Gachsaran Polymer Industries Company PIDMCO	Gachsaran Polymer Industries Company HDPE Plant				
	LCP and Junction Box Layout, Arrangement and Wiring Drawing for Refrigerator Package		 		
PO No.: GPIC-PT-MA-PO-000-3029	Document Number: VD-GPIC-MA-3029-3029-0046	Rev. 01	Page 1 of 14

LCP and Junction Box Layout, Arrangement and Wiring Drawing for Refrigerator Package

LCP-6101A

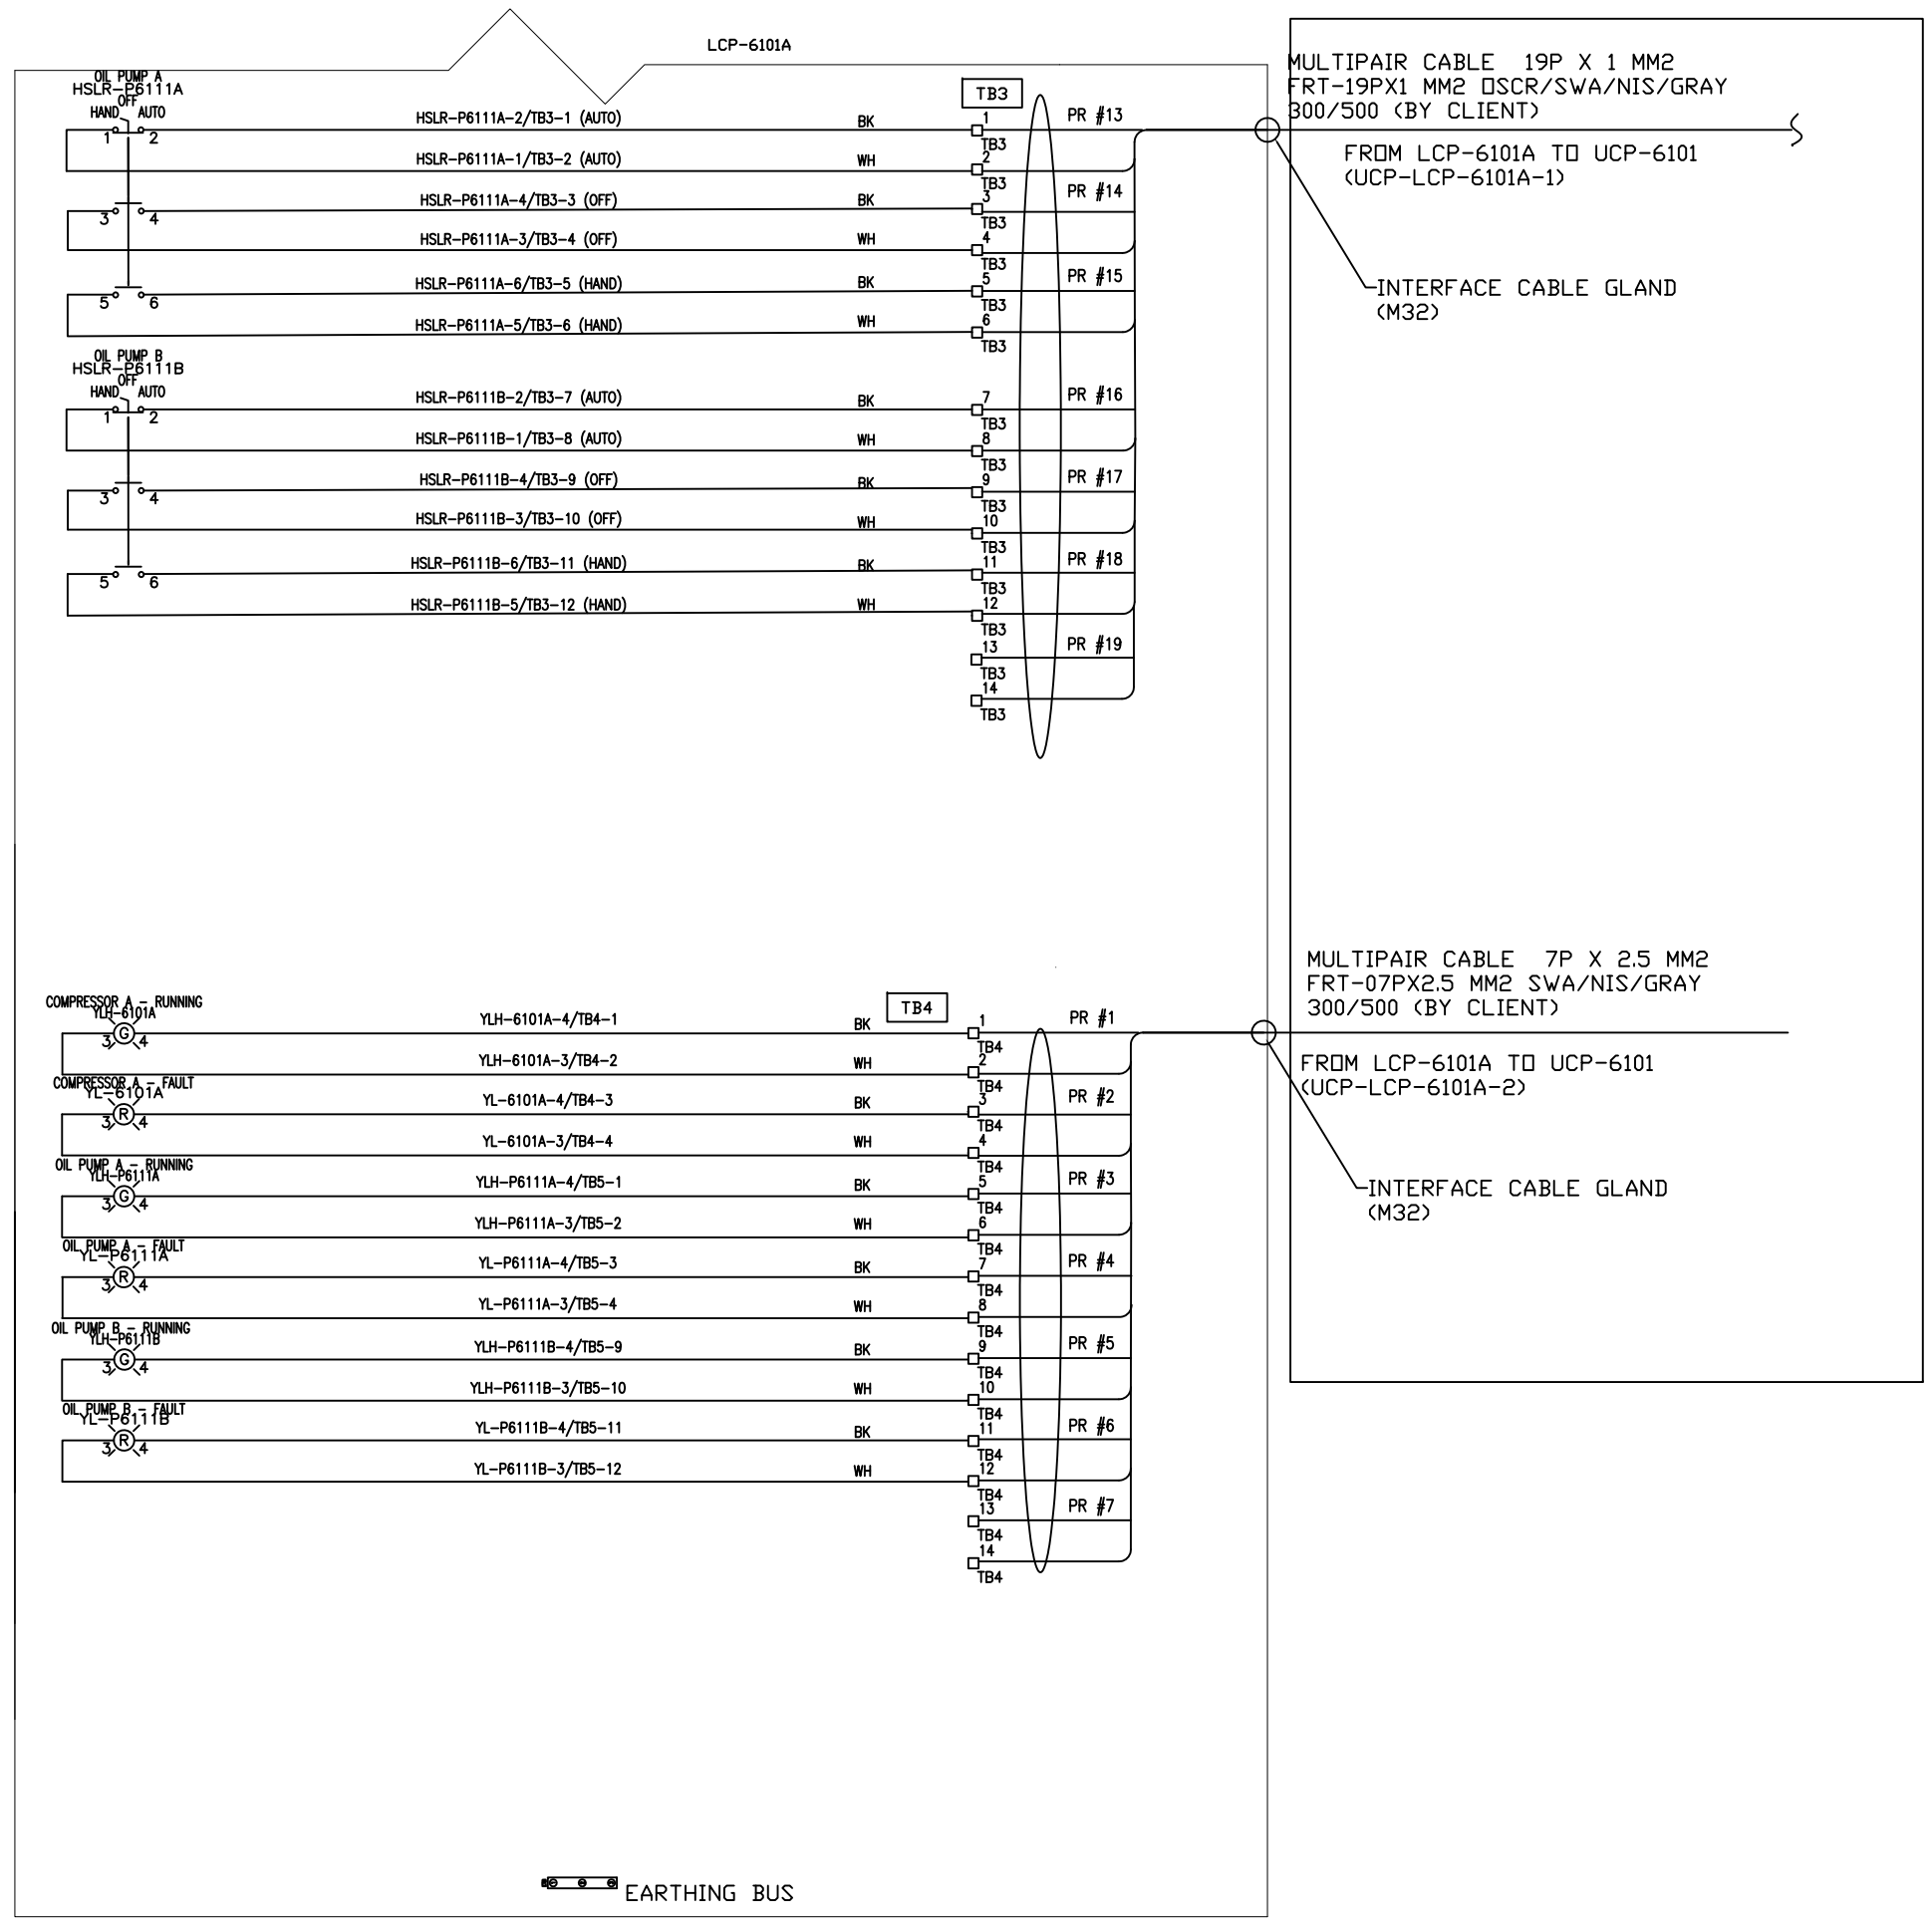
Be note that RTD for winding & Bearing shall be connected to UCP, so all I/O & Related cable shall be considered for connection in this document or related document.

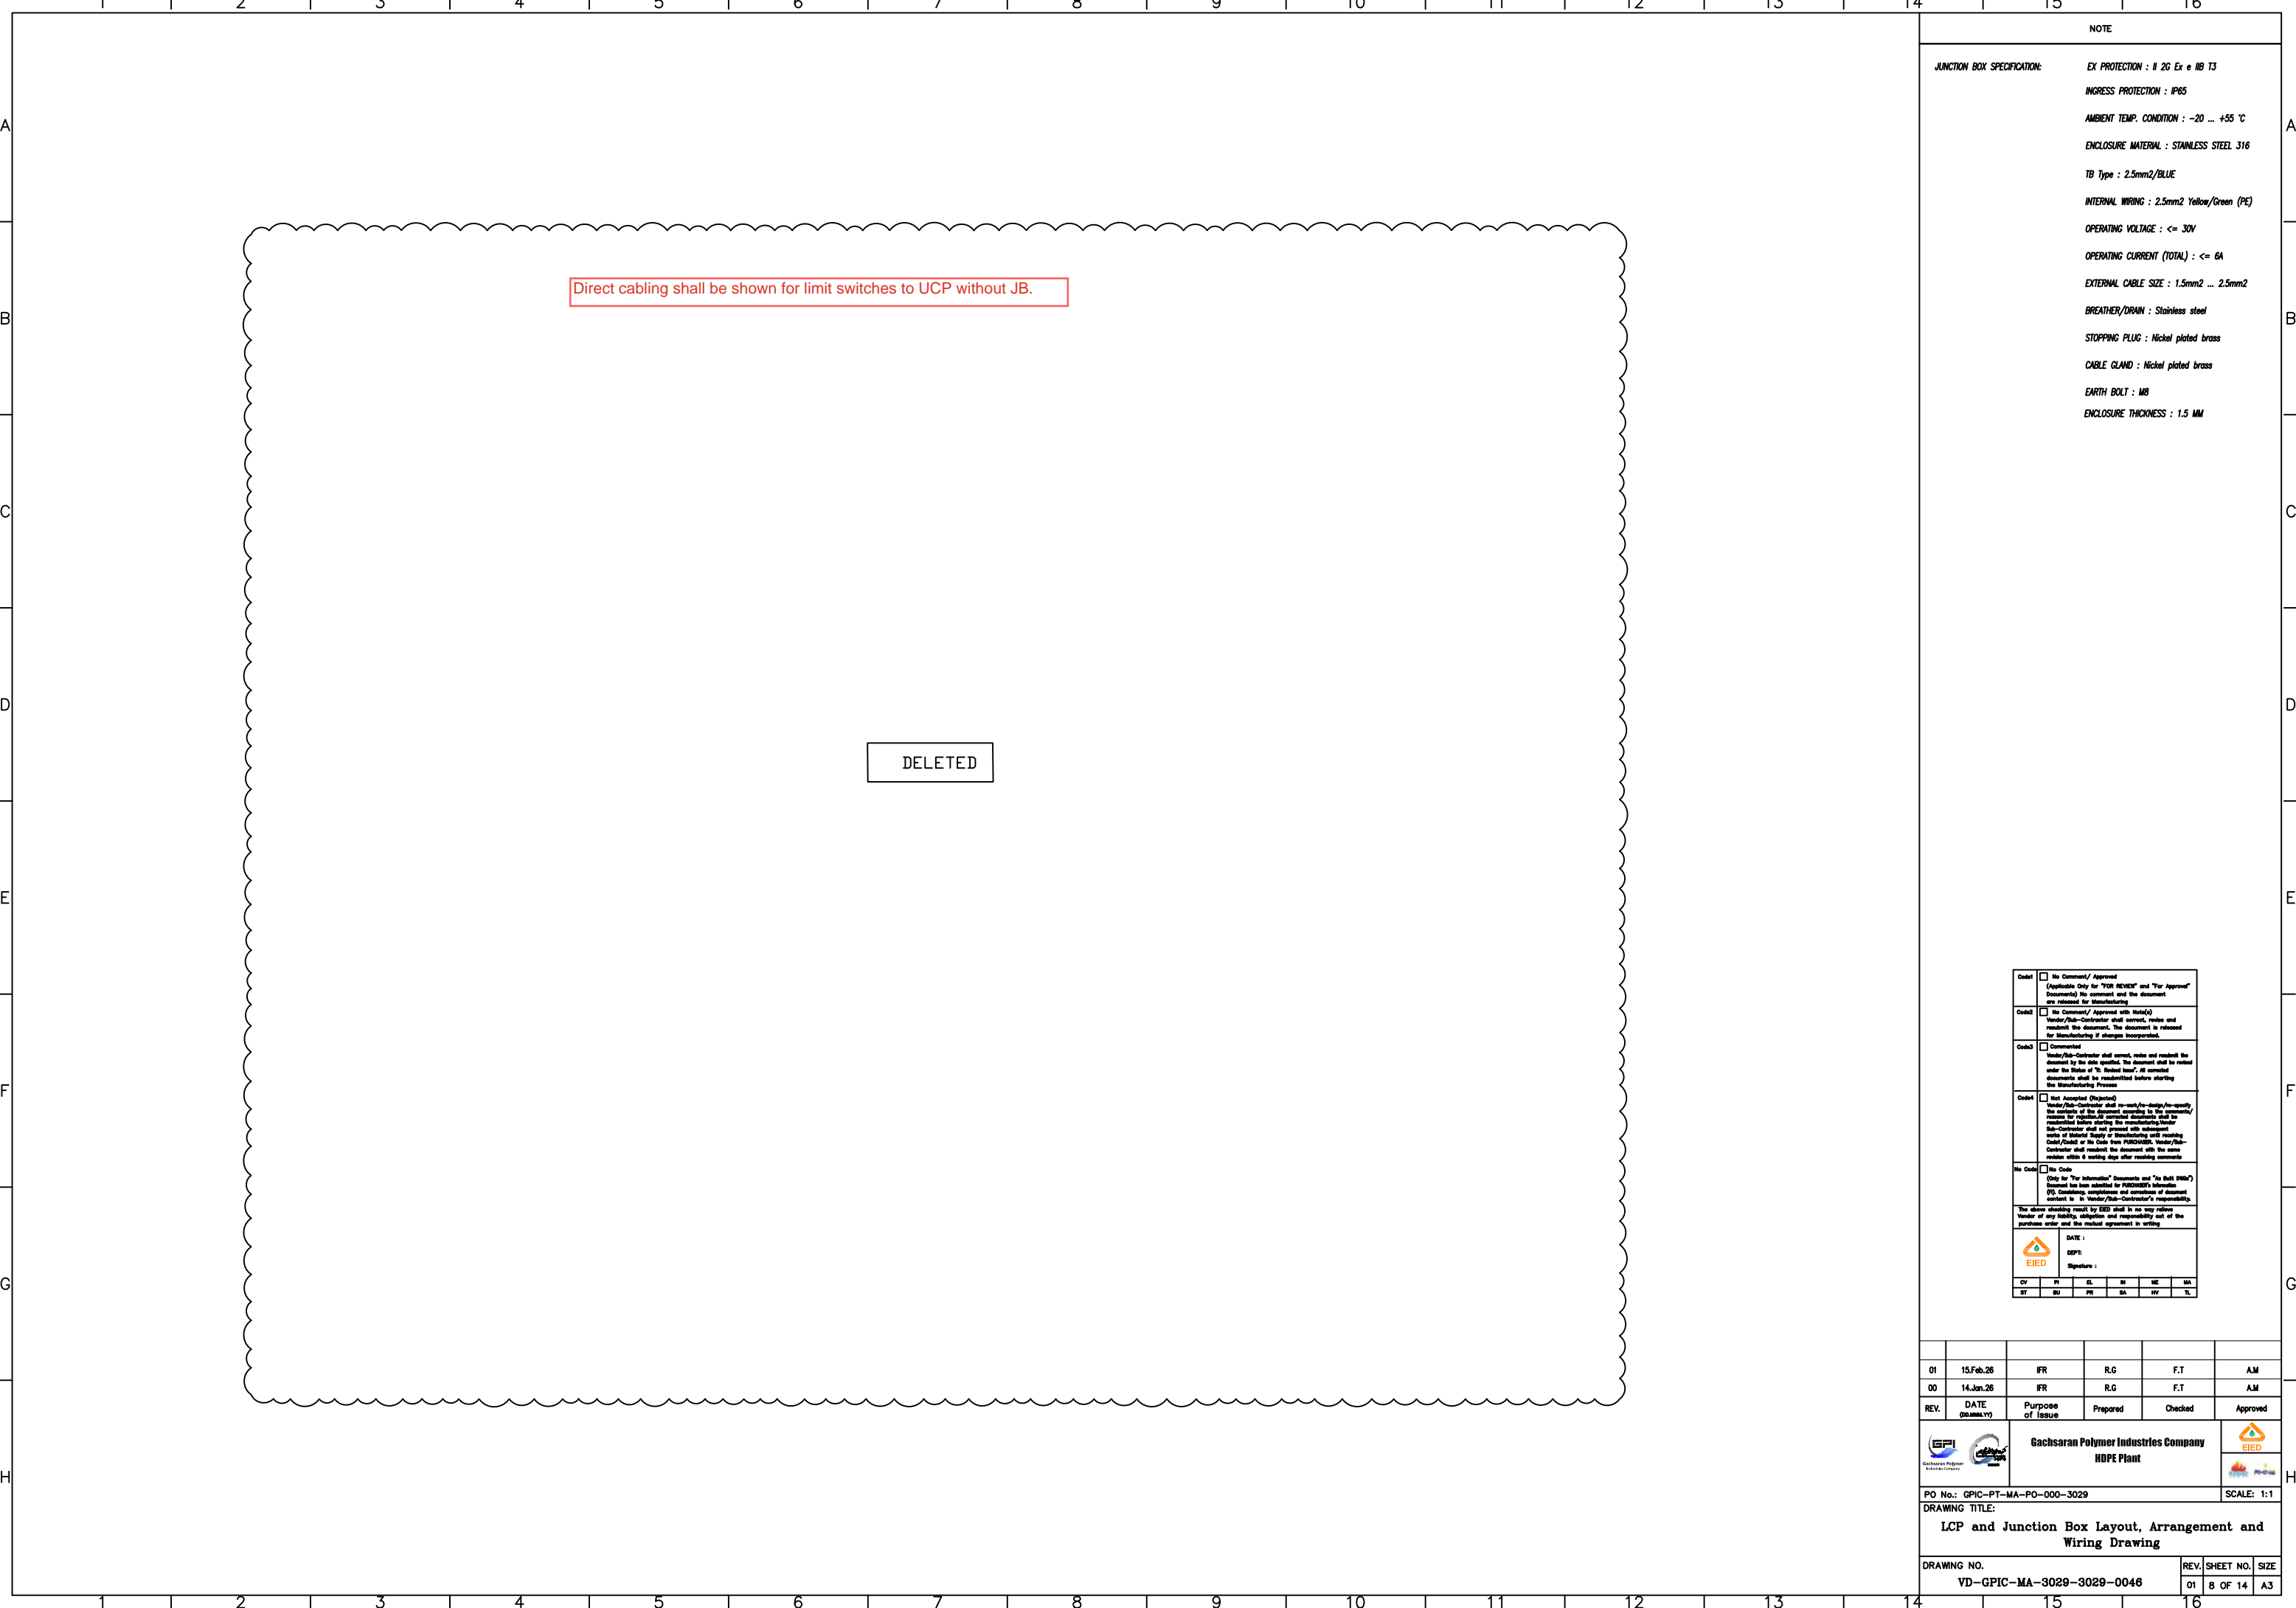
Direct cabling shall be shown for limit switches to UCP without JB.

FROM HTR-E6101 TO MCC
 (TS-EH6101)

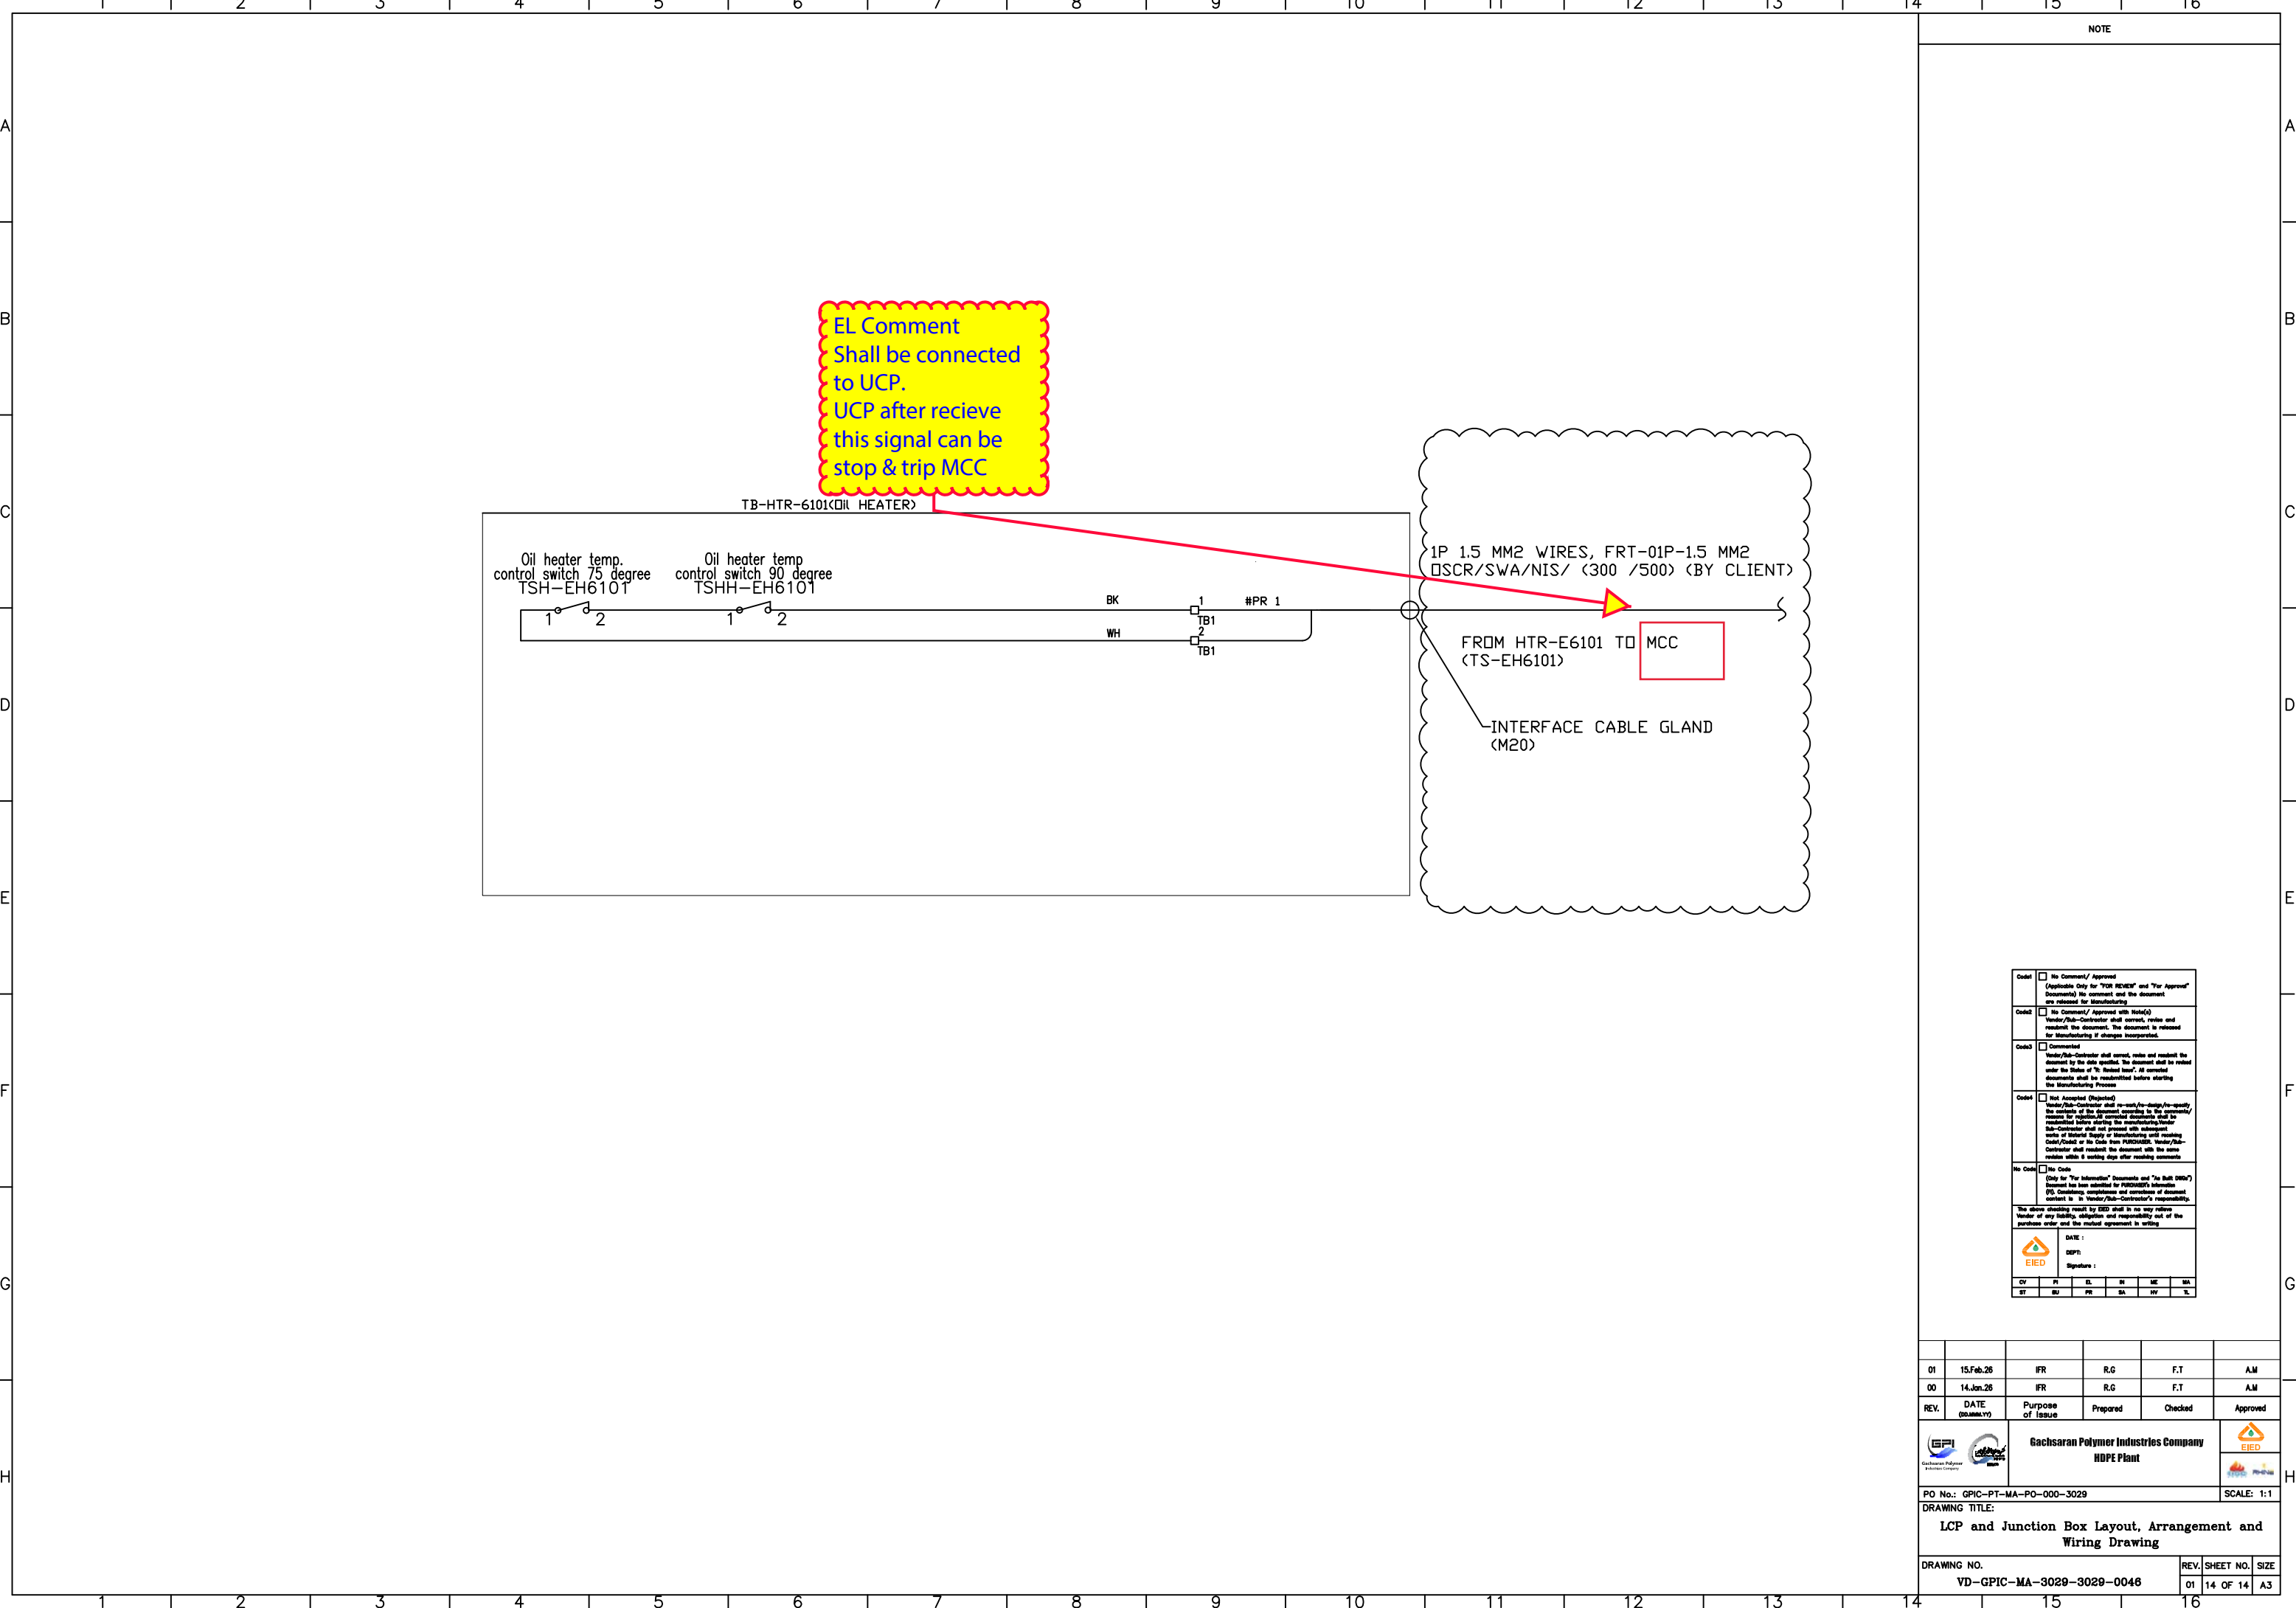
EL Comment
 Shall be connected
 to UCP.
 UCP after receive
 this signal can be
 stop & trip MCC
